Service Bulletin

Subject: 2013-2014 CX-5 - VARIOUS ELECTRICAL SYSTEM MALFUNCTION(S) RELATED TO C-15 CONNECTOR CORROSION	Bulletin No: 09-041/15
	Last Issued: 10/14/2015

- This bulletin supersedes the previous bulletin 09-005/14, issued on 01/14/14, 02/07/14, 03/14/14, 05/08/14 and 09-031/13, issued on 11/11/13. The REPAIR PROCEDURE, PART(S) and WARRANTY INFORMATION has been revised.
- Changes are noted below in Red beside the change bar.

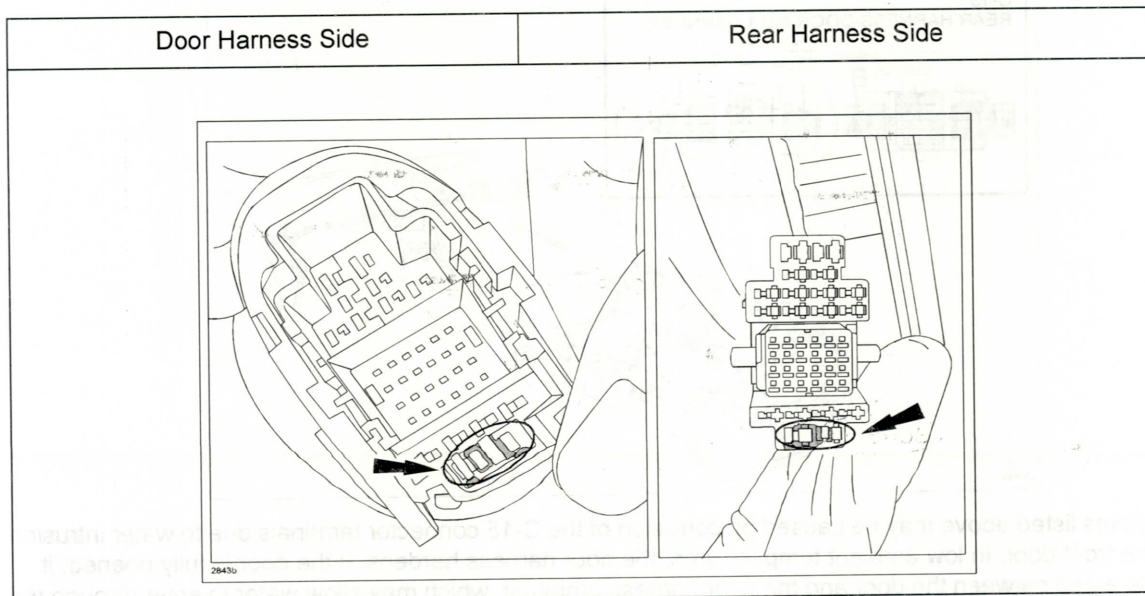
MASS PRODUCTION CHANGES:

- The front door harness grommet has been changed to improve sealing performance.
- Holes inside the front pillar (which are made for weight reduction), have been covered to prevent water intrusion.
